FINAL PLAT
SPOTSWOOD ADDITION
TO SEDGWICK COUNTY, KANSAS

RE: SUB 2001-49 -- One-Step Final Plat of Spotswood Addition

RE: SUB 2001-49 -- One-Step Final Plat of Spotswood Addition

CASE NUMBER: SUB 2001-49 -- SPOTSWOOD ADDITION

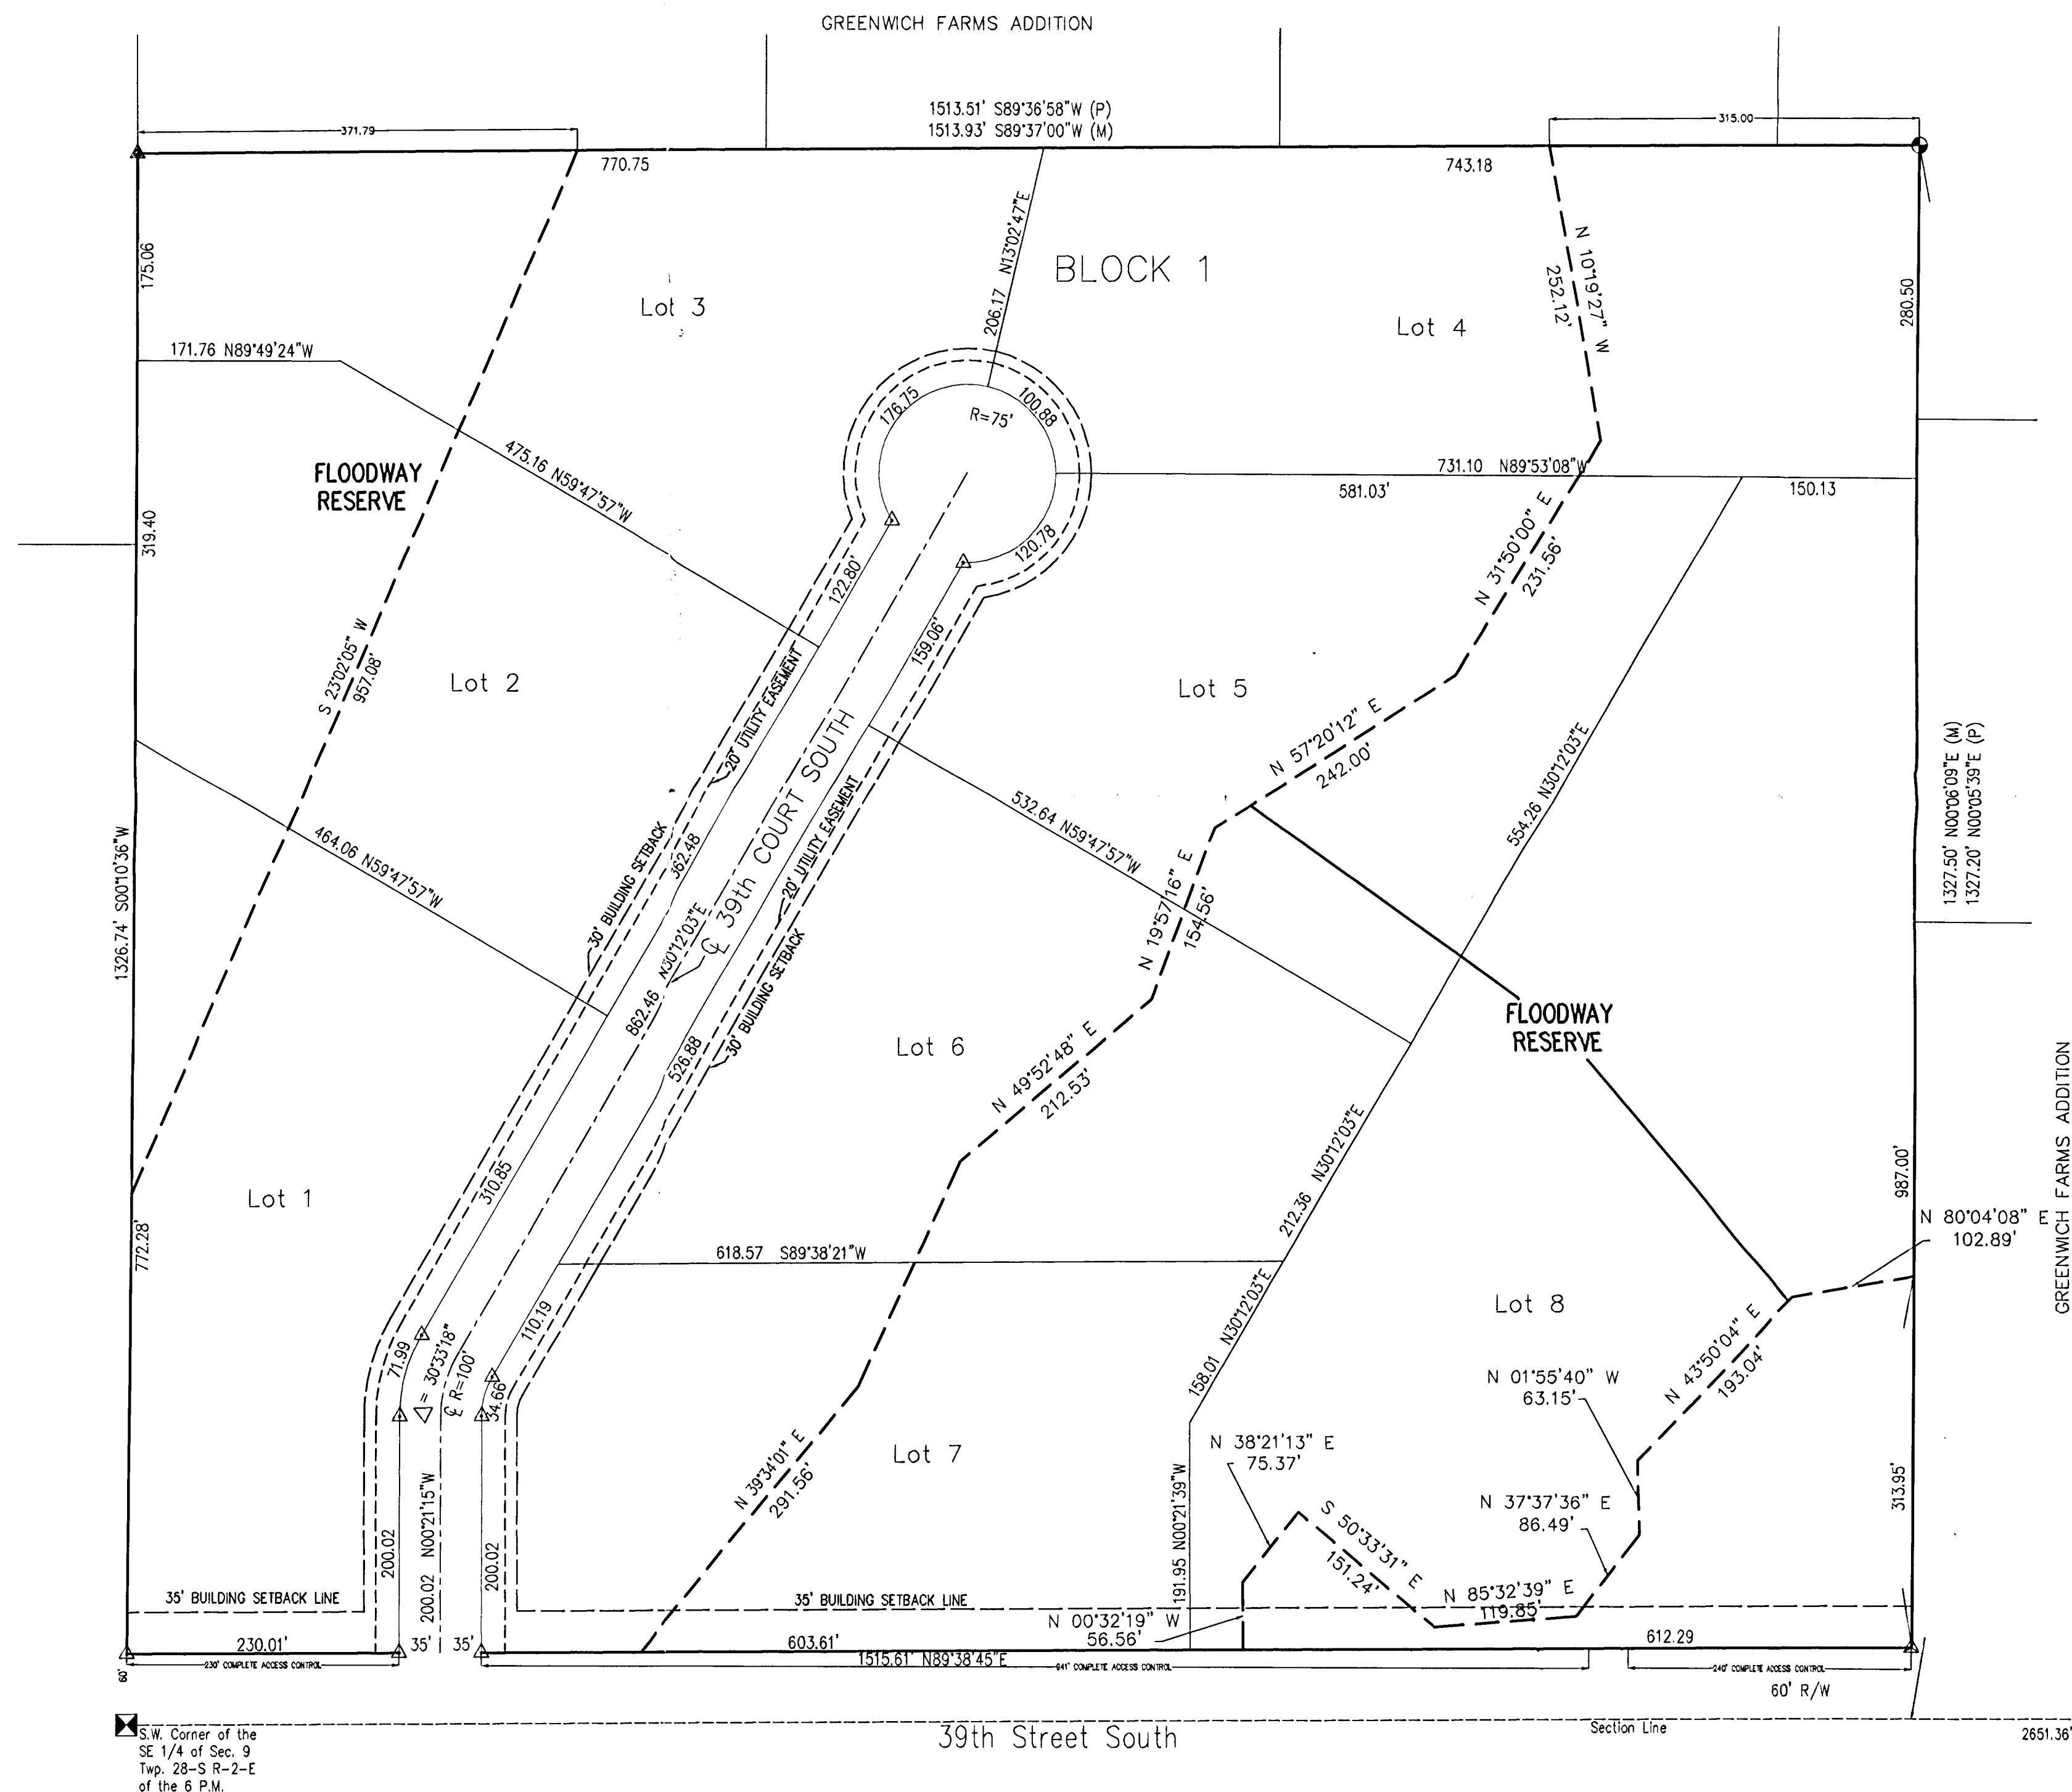
- D. County Engineering needs to comment on the status of the applicant's drainage plan. The drainage plan is approved. A flood study is required. A minimum pad elevation needs to be established. A drainage reserve is required between Lots 6 and 7.

- G. The diameter of the turnaround should be increased to 150 feet to conform with Subdivision Regulations.
- H. County Engineering needs to comment on the access controls. The plat proposes one access opening along MacArthur Road for Lot 1, Block 2. One opening is approved.

- I. The plat shall be included within one block. Lot 1, Block 2 should be labeled as Lot 8.
- J. The applicant shall guarantee the installation of the proposed street to the 36-ft rock suburban street standard. County Fire Department has required that the street be installed prior to the issuance of building permits.

- O. The applicant is advised that if platted, the building setbacks must be 35 feet along MacArthur Road to conform with the Zoning setback standard for County section line roads.

- P. Approval of this plat will require a waiver of the lot depth to width ratio for Lot 4, Block 1. The Subdivision Regulations state that the maximum depth of all residential lots shall not exceed 2.5 times the width. The Subdivision Committee has approved the modification..
